# SERVICE BULLETIN

## SB-012724-A

**ID NUMBER & REVISION:** SB-012724-A  
**SUBJECT:** NLG Limit Switch Retrofit  
**RELEASE DATE:** 16 May 2024  
**EFFECTIVE DATE:** 16 May 2024  
**SUPERSEDES NOTICE:** SB-080323-B  
**AIRCRAFT AFFECTED:** **MAKE & MODEL:** ICON A5  
**SERIAL NUMBERS:** If SB-080323 was NOT completed: 00001-00015, 00018-00027, 00029-00033, 00035, 00036, 00038-00049, 00051-00072, 00074, 00076-00083, 00085, 00086, 00088-00182, 00184-00188

**REQUIRED ACTION:** Retrofit reed switch style NLG actuators with mechanical limit switches with long arms.

Figure 1. Bracket Modifications for 10-32 Studs

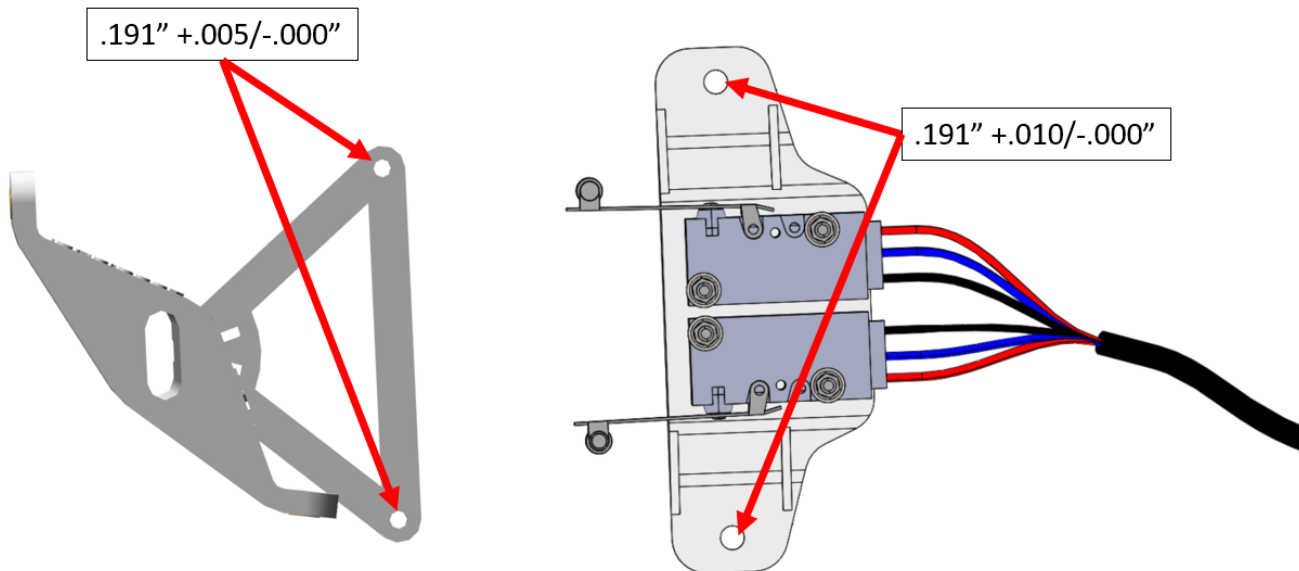
If using either kit with 10-32 studs (ME001206 or ME001207), complete the following bracket and tool modifications. (If using 8-32 studs, continue to INSTRUCTIONS.)

1. Drill the 2x holes in the Limit Switch Bracket Fixture (part of ME001201) to  $.191" +.005/-.000"$ .
2. Drill the 2x holes in the Limit Switch Subassy Bracket (ME001202 or part of ME001203) to  $.191" +.010/-.000"$ .

Figure 5. NLG Connector D9024J, Wedge Lock (orange)

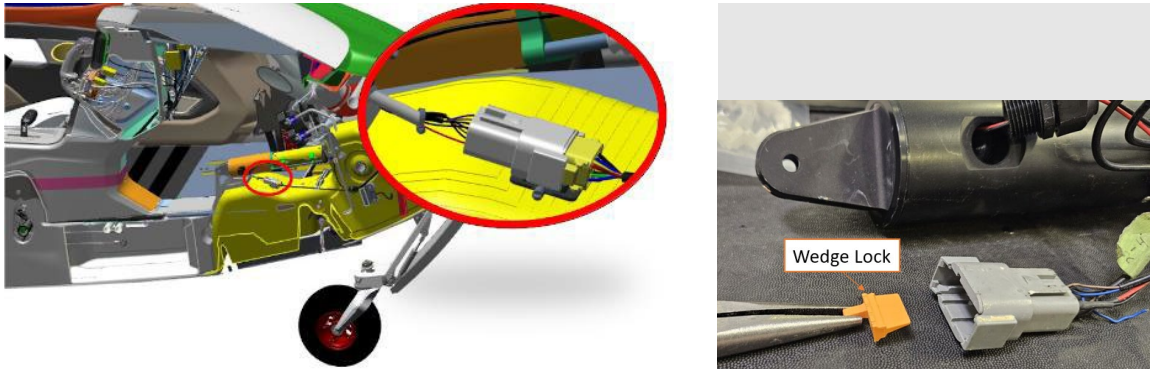
2. Remove the instrument panel top(s) (See Aircraft Maintenance Manual, Section 100514 or 100547/100397).
3. Modify the NLG actuator harness as follows:
  - a. Cut zip tie around NLG connector and disconnect the NLG connector D9024J. (Reference **Figure 5**.)
  - b. Remove Wedge lock from actuator-side connector body. (Reference **Figure 5**.)

Figure 6. Trim wires at reed switches

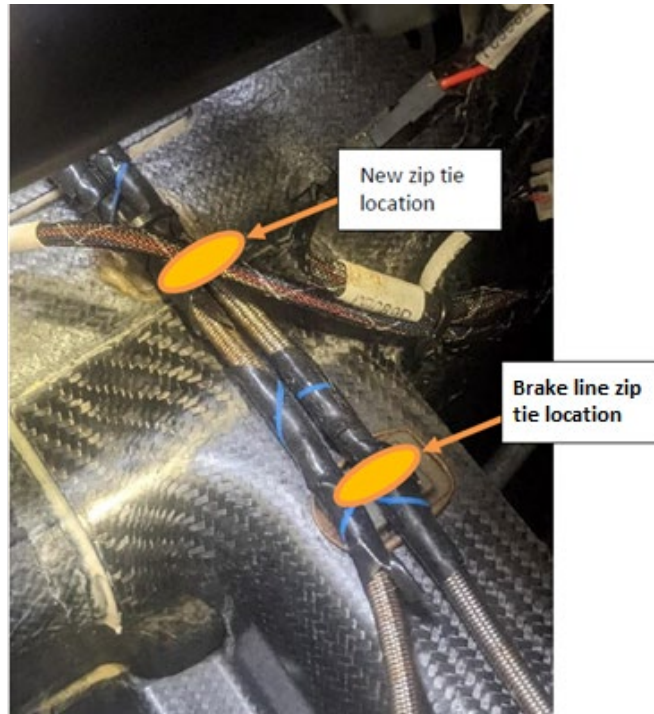
- c. Mark wires pinned to connector positions 1 and 8 with masking tape. Remove all electrical connector pins/wires in the existing NLG connector PN D9024J, (located on the actuator side).
    - d. Remove sleeving from the actuator wire bundle and pull the wires out of the bundle that leads to the magnetic reed switches located on the connector body. Note: The reed switch wires are encased in larger black insulation. Trim the reed switch wires where they exit the reed switches as shown in **Figure 6**. Discard these trimmed wires. Note: the wires that were located in connector positions 1 and 8, the red and black wires that enter the actuator body and were marked in step c, must not be trimmed or altered in any way.

*Figure 7. Zip- tie Locations*

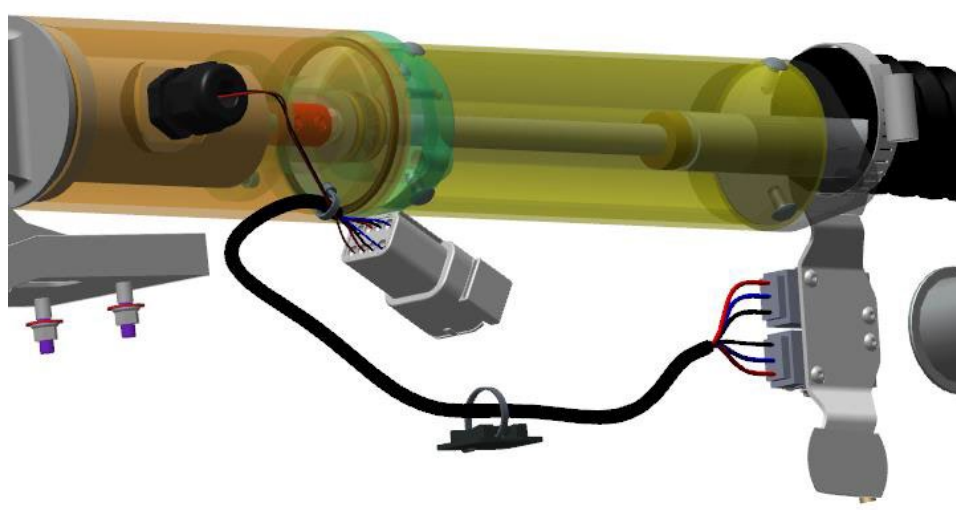
- (1.0 config only) Remove zip- tie securing the wiring harness to the brake line (**Figure 7.**)  
NOTE: If additional slack for harness is needed, it is permissible to also relocate the zip- tie shown in **Figure 18.**

*Figure 9. NLG Bell crack Shaft bolt*

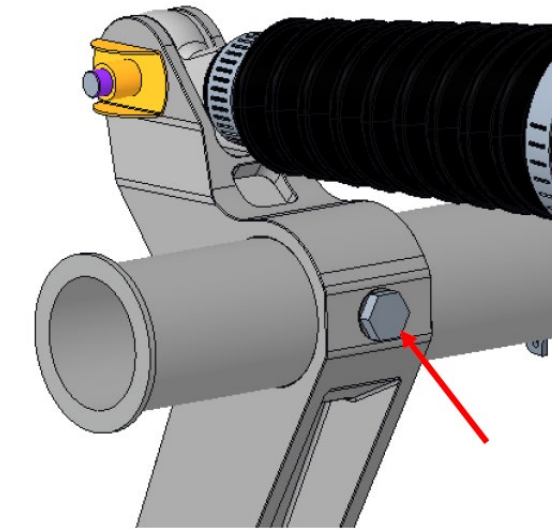
7. Preinstall the new retrofit Limit Switch Bracket sub-assembly into the bell crank shaft. Orient the assembly so it slides over the bell crank shaft bolt shown in **Figure 9**.
8. If needed, identify any areas of interference between the Limit Switch Bracket and ECS heater bracket by pre-installing 1 each of the CLICKBOND studs (CB4000G08CRA8P750 or CB4000G3CRA8P750) approximately as shown in **Figure 10**. Mark the area of interference with ECS heater bracket with a permanent black marker. Loosen from each CLICKBOND stud, shim the gap and cut away interference area with a hand cutting tool. Be careful not to damage the surrounding area. Clean working area to remove all FOD, including carbon dust, with a shop vac.

Figure 12. Cross-section view of installed bracket

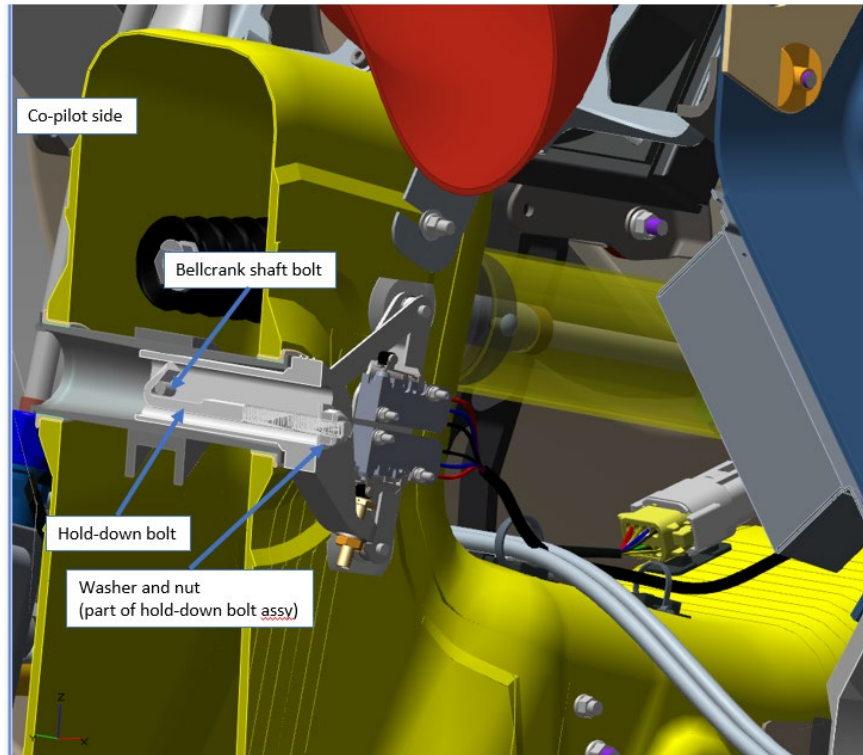
9. Insert Limit Switch Retrofit Bracket into the bell crank shaft, orient it so it slides over the bell crank shaft bolt shown in **Figure 9** above. Remove zip-tie from hold down bolt assembly, remove and retain the washer and nut. Insert hold down bolt from co-pilot side of NLG box, and secure with 1 each retained washer and 1 each locking nut (95615A120) on the pilot side of the NLG Box. Torque to 17±2 in-lbs. (Reference **Figure 12**)

Figure 13. Harness routing and edging

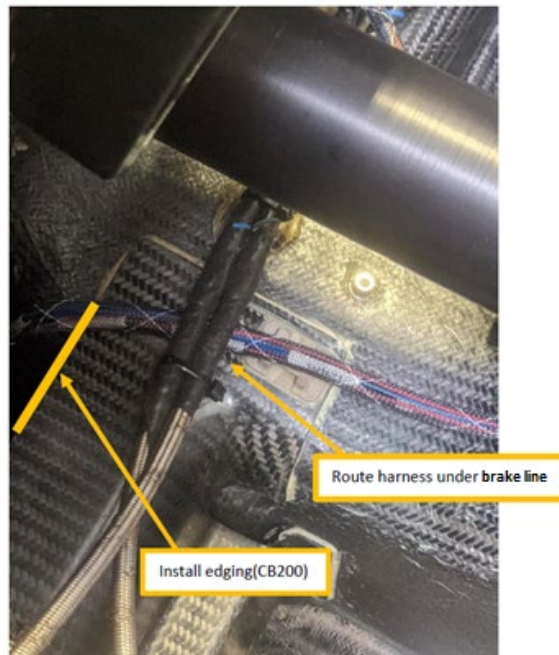
10. Apply a generous amount of lubricant (ICA012078) over exposed thread end of hold-down bolt.
11. Prepare 2 each CLICKBOND (CB4000G08CRA8P750 or CB4000G3CRA8P750) and surface for bonding, in accordance with adhesive manufacturer recommendations.
12. With rig pin still installed, or using ITL001714 if no rig pin hole is available, bond CLICKBOND studs (CB4000G08CRA8P750 or CB4000G3CRA8P750) in the place oriented by the fixture (Reference **Figure 11**). Bond using CB200 in accordance with manufacturer recommendations. Backfill as needed with CB200 where stud overhangs core.
13. After allowing to adequately cure, use a razor knife to carefully trim away the fixture close to the base as shown in red line in **Figure 11**.
14. (1.0 config only) Install edging (MS21266-1N Grommet Edging)) with CB200 at location shown in **Figure 13** and route harness as shown.

Figure 14. Installed limit switch subassembly; (1.0 config: Orient as shown on right)

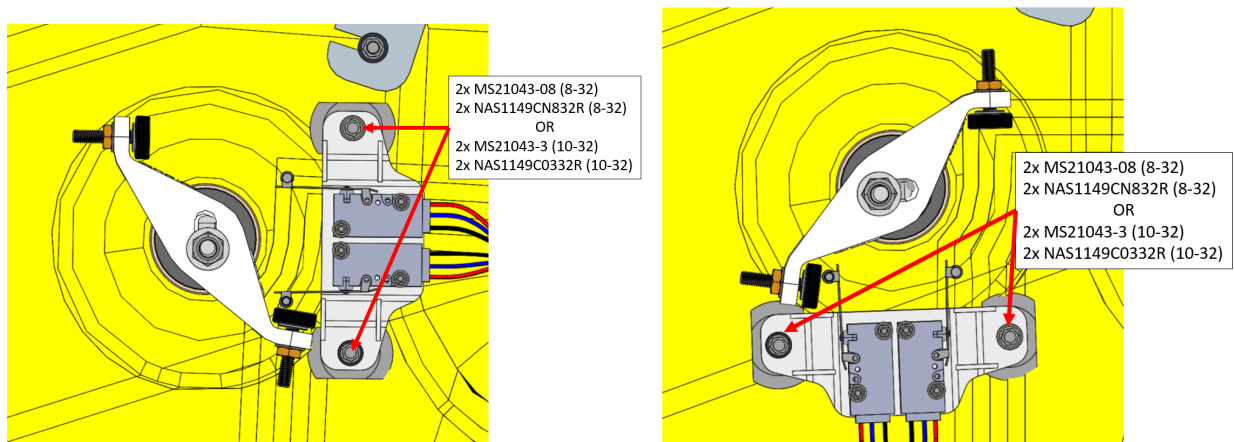
15. Using isopropyl alcohol, clean surfaces where lubricant will be applied. Apply ICA012078 Tef-Gel to the threads of the studs. Install limit switch assembly onto studs with 2x NAS1149CN832R washers and 2x MS21043-08 nuts torqued to 14 in-lbs (if 8-32 studs were used), or with 2x NAS1149C0332R washers and 2x MS21043-3 nuts torqued to 20 in-lbs (if 10-32 studs were used) as shown in **Figure 14** below.

Figure 15. Adjust thumbscrew gap

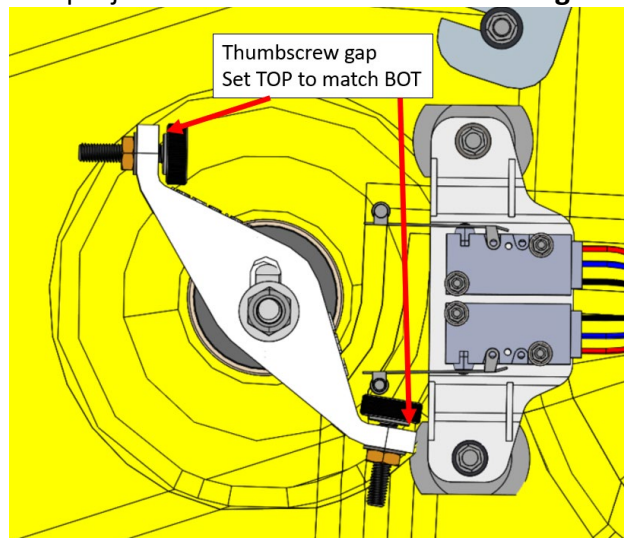
17. Adjust thumbscrew on limit switch retrofit bracket so bottom (“BOT”) extended limit switch is activated. Adjust thumbscrew gap on limit switch retrofit bracket so that top (“TOP”) side has the same gap as the bottom. Torque jam nut to  $15 \pm 2$  in-lbs. Reference **Figure 15**.

Figure 18. NLG retrofit Tie mount block

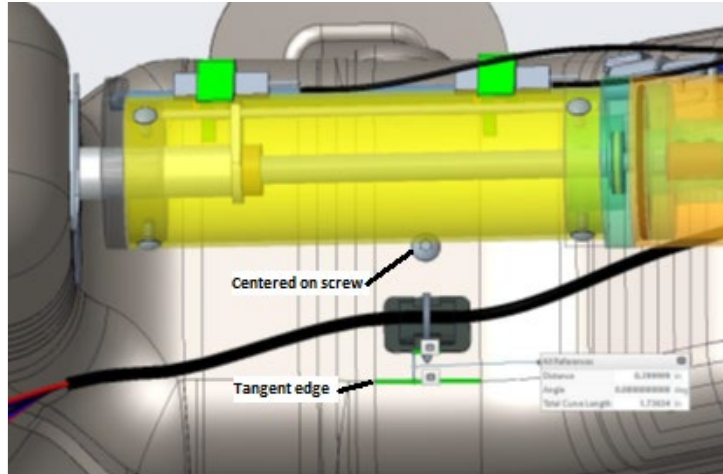
20. Install tie mount on the NLG box. Center the mount with screw and about 0.400 inch upwards from tangent edge as shown in **Figure 18** below.
